## United States Department of the Interior

IN REPLY REFER TO:  
A.1.2.(NER-RSS)

**Subject: Dominion Surry-Skiffes Creek Whealton Project - Tribal Consultation, the Yorktown Power Station, Project Alternatives and Load Growth**

**Figure 1:** Total net generation for all three units from all fuel sources at the Yorktown Power Station, January 2008-July, 2016 from Form EIA-923.<sup>6</sup>

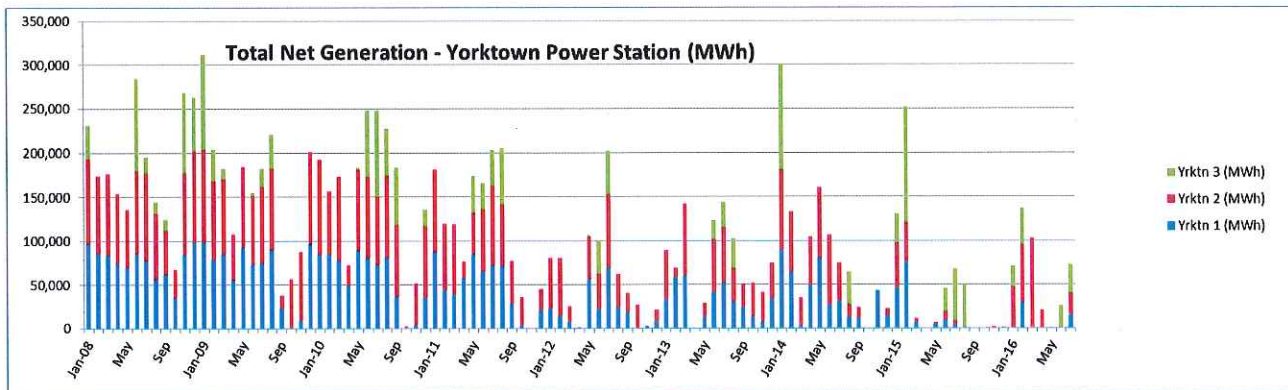
As Figure 1 indicates, generation from all three units has declined over time. In January, 2009 the station reported peak generation of 312,288 MWh. Averaged over the entire month, the station generated 420 MW, well below its maximum capacity of 1,141 MW, yet still the highest generation over the last eight years. We do not know if the Yorktown Power Station operated all 31 days of the month, so the MWs generated could be higher. But this points to another observed trend: as generation has declined, Yorktown seems to have moved from being a baseload operator counted on to supply electricity at all times, to a peaking plant counted on mostly during the coldest parts of the winter and to a lesser degree during peak electricity demand in the summer.

**Figure 2:** Total net generation from all fuel sources for Yorktown Unit 1, described as a coal plant, January 2008-July, 2016.<sup>7</sup>

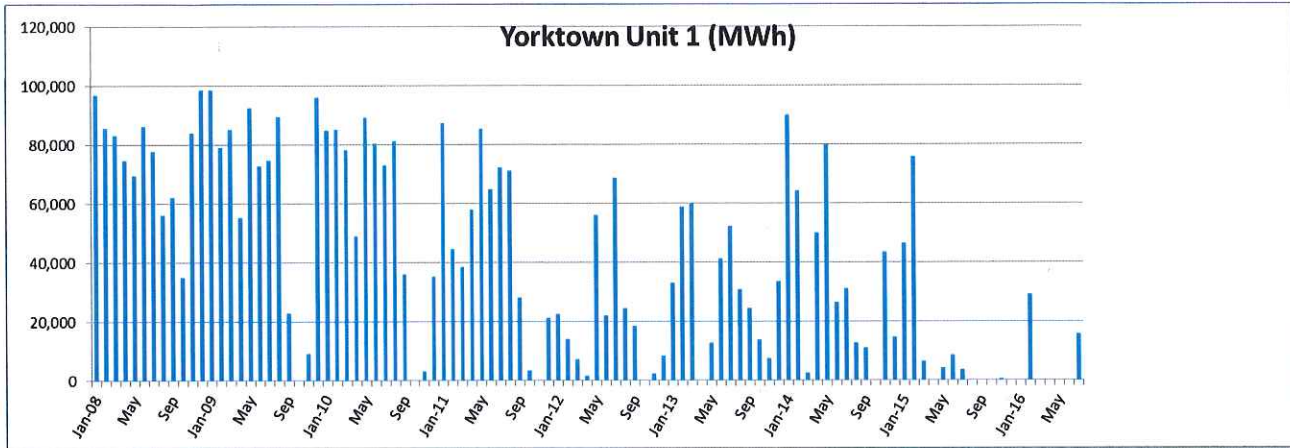
Examination of each unit individually highlights this trend. As shown in Figure 2, Yorktown Unit 1 has seen a decline in operations since 2008 and a marked decline in generation since 2015. In July, 2016 (the most recent reported month available), Unit 1 generated 15,866 MWh, averaging just over 21 MW for the month. This is an average; if Unit 1 was only needed for a few peaking days and wasn't in operation for the full month, the MW total would be higher. But the trend line is unmistakable.

**Figure 3:** Total net generation from all fuel sources for Yorktown Unit 2, described as a coal plant, January 2008-July, 2016.<sup>8</sup>

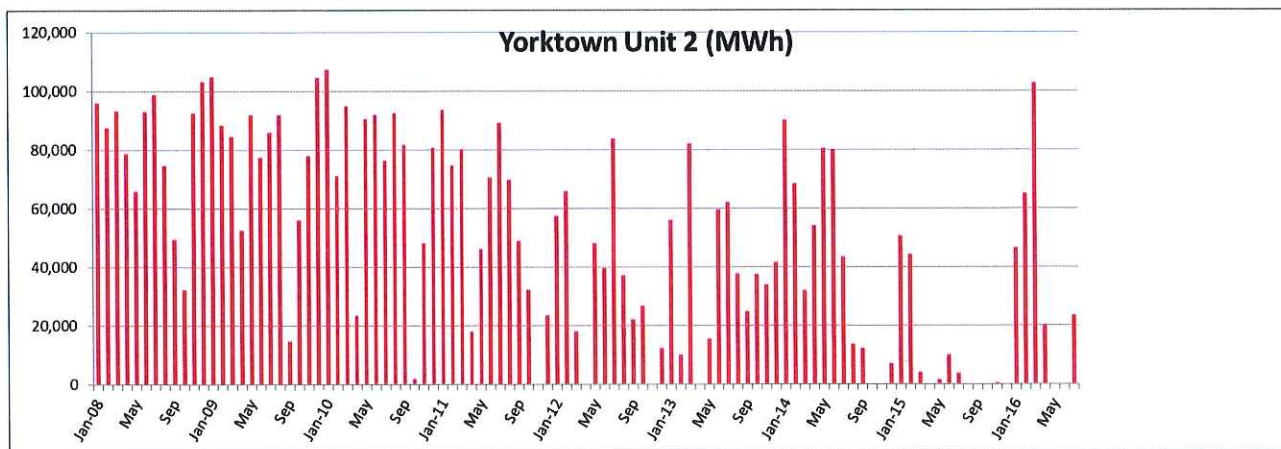
The data for Unit 2 shows a similar situation. Use has decreased significantly over time, with mostly peaking use since 2015. While some of this decline for Units 1 and 2 may be related to decisions in complying with the Environmental Protection Agency’s Mercury and Air Toxics Standards (MATS), it is true that reliance on these plants for electricity generation has markedly decreased and both units have been shut down completely for months at a time without ill effect to the electrical grid or service to customers. The amount of electricity needed to meet peak demand and the number of days of operation during peak demand months for these units should be disclosed to more accurately understand the load that must be replaced, the true nature of the need for this project, and the range of alternatives that might meet the need.

**Figure 4:** Total net generation from all fuel sources for Yorktown Unit 3, described as an oil-fired plant, January 2008-July, 2016.<sup>9</sup>

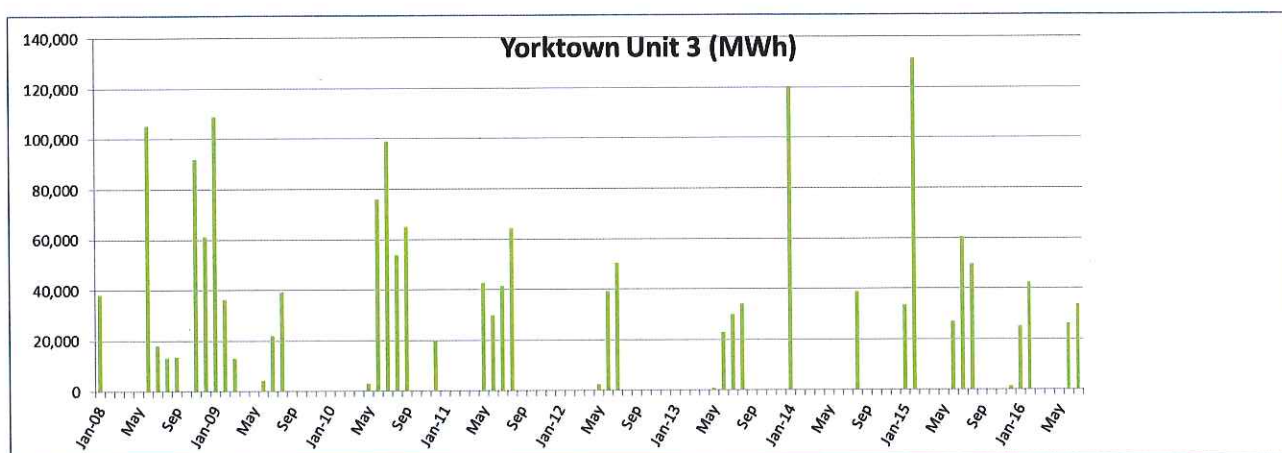
Form EIA-923 data for Unit 3, the Yorktown oil-fired unit, tells a slightly different story. Use has been intermittent since at least 2008, but is on the decline. Unit 3 operations are constrained, “Due to environmental restrictions Dominion can only operate Yorktown 3 intermittently (8% of year).”<sup>10</sup> Unit 3 generation since 2008 has been concentrated on peak periods. It is unclear when these environmental restrictions were put in place, and what effect, if any, they have had on the operation schedule and output of Unit 3. NPS requests more information from the USACE on this topic.

**Figure 5:** Use of distillate fuel oil as a generation fuel source at Yorktown Unit 2, January 2008-July, 2016.<sup>16</sup>

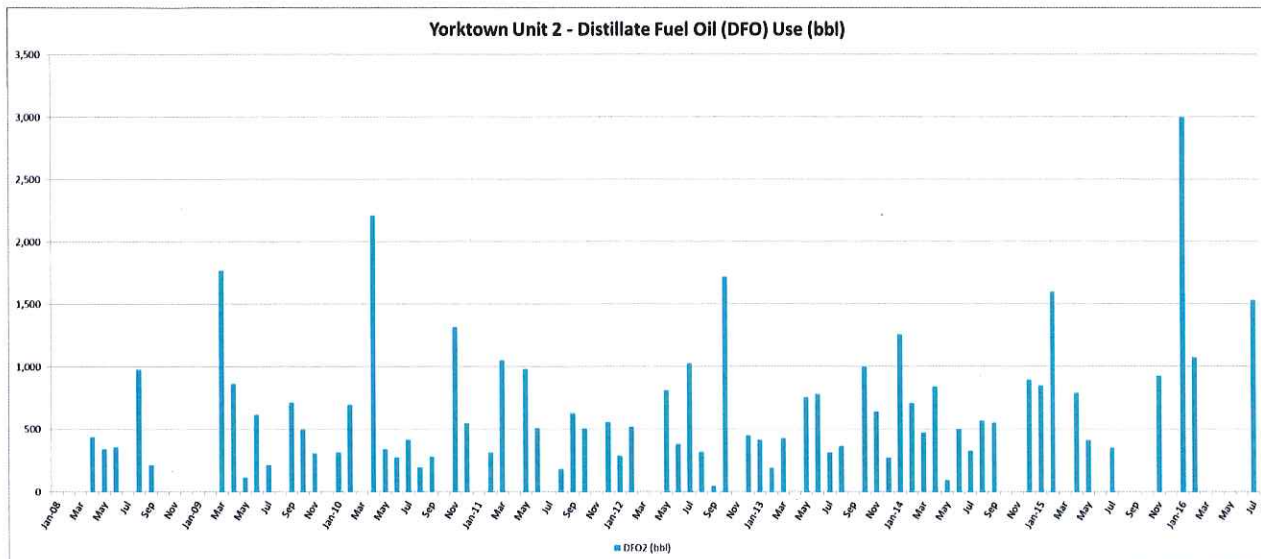
NPS finds this potential repowering of Unit 2 somewhat confusing in that Unit 2 is already capable of burning oil (DFO) and has been doing so since at least 2008<sup>15</sup>, as shown in Figure 5.

A more fitting scenario to examine would be the closure of Unit 2 and the conversion of Unit 1 to natural gas and oil, and Unit 3 to natural gas and oil. It would be more fitting since this is what is, and has been, actually occurring at Yorktown Power Station since at least March of 2008 for Unit 1 and at least January of 2008 for Unit 3. NPS has examined Form EIA-923 data<sup>17</sup> for each unit at the Yorktown Power Station. These records show that both Unit 1 and Unit 3 are capable of and have been burning natural gas for power generation since at least 2008. And 2008 does not appear to be the first year in which natural gas was used. Examination of historical data<sup>18</sup> from Forms EIA-906, EIA-920 and EIA-923 show small amounts of natural gas use since at least January of 2001.

**Figure 6:** Use of natural gas as a generation fuel source at Yorktown Unit 1, January 2008-July, 2016.<sup>19</sup>

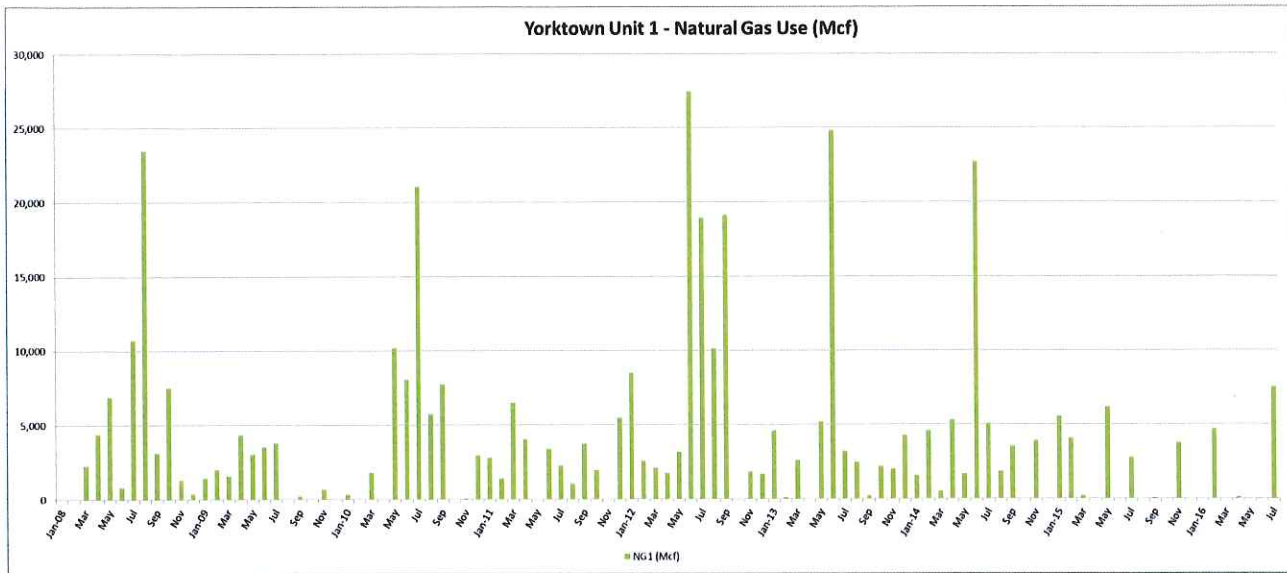
As shown in Figure 6, natural gas use in Unit 1 has been occurring for a number of years. Much of this use has been concentrated in summer peaking periods.

**Figure 7:** Use of natural gas as a generation fuel source at Yorktown Unit 3, January 2008-July, 2016.<sup>20</sup>

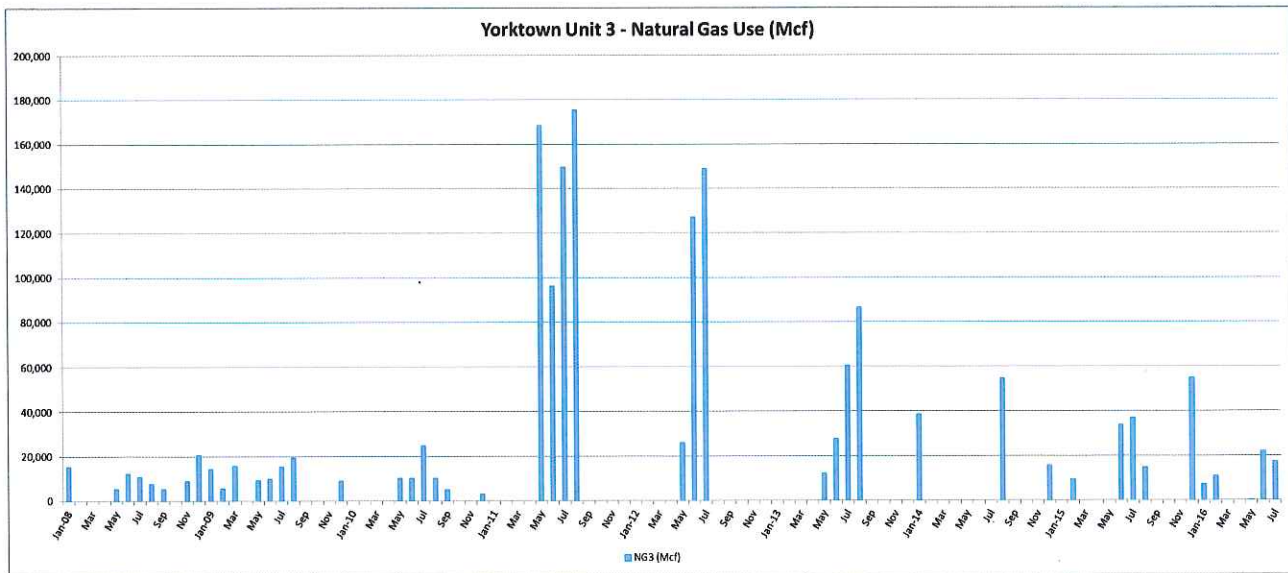
Use of natural gas in Unit 3 has been more intermittent, but in higher volumes. Much of this use has also been concentrated in summer peaking periods.
